# Technical Service Information

## CHRYSLER A604 DELAYED FORWARD ENGAGEMENT

Figure 1

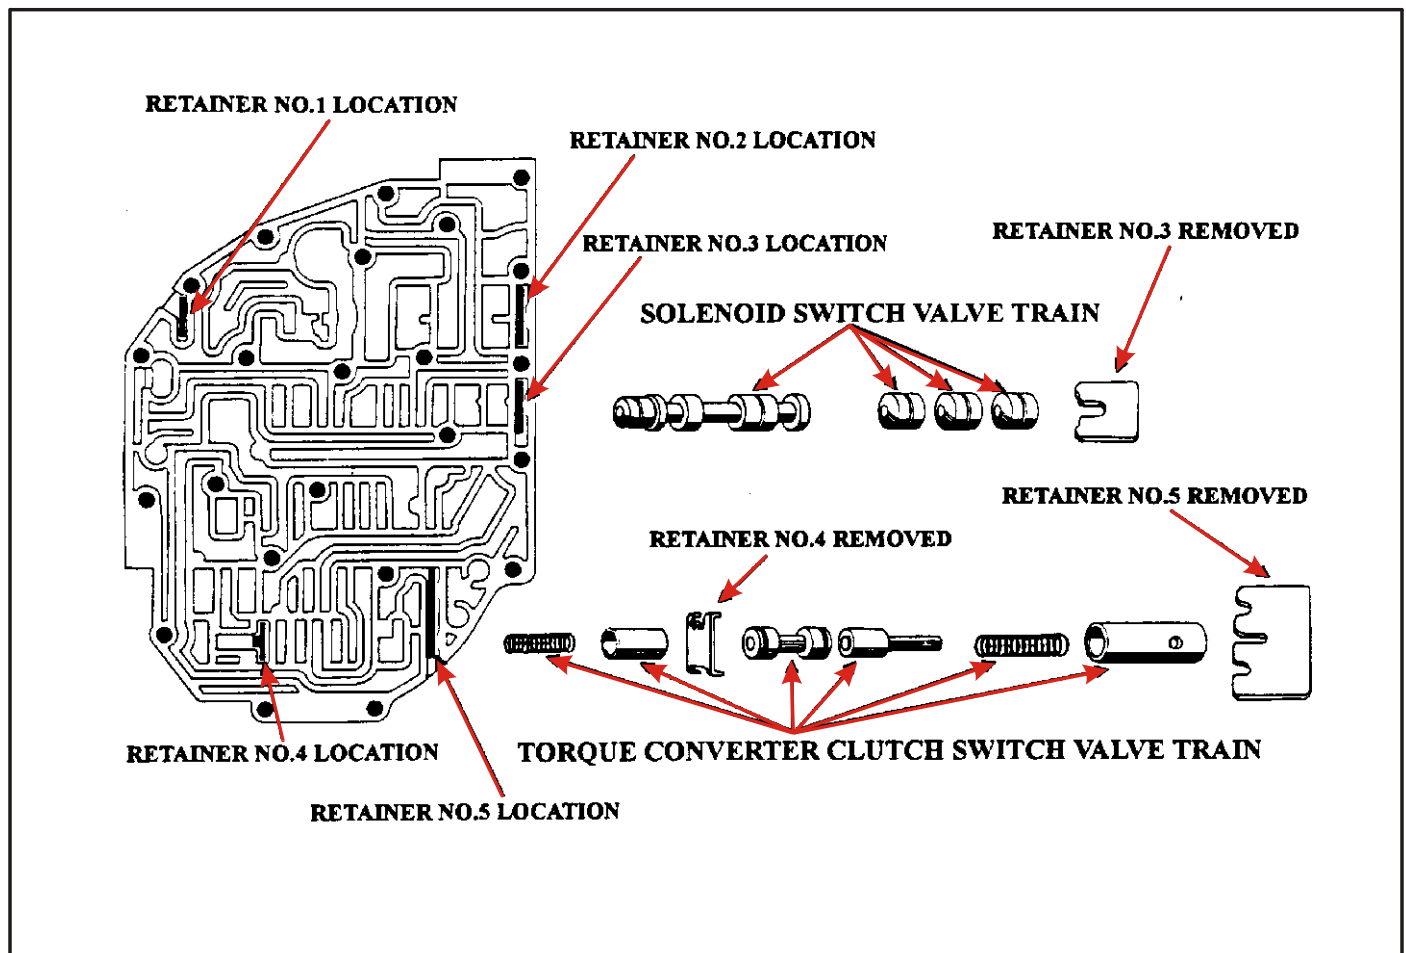
**COMPLAINT:** After overhaul vehicle exhibits delayed and/or a shuddering condition, when shift lever is engaged into any forward range, followed by an immediate abort to "Limp Mode."

**CAUSE:** The cause may be, that during the valve body cleaning process, retainer No.3 and/or one of the small "Buttons" in the solenoid switch valve train was not installed during reassembly. These parts can usually be found in the bottom of the solvent tank.

**CORRECTION:** Install the solenoid switch valve train and retainer No.3 as shown in Figure 1.

**NOTE:** Retainer location No. 4 and Torque Converter Clutch Switch Valve Train shown in Figure 1 are for '92 " and later only!
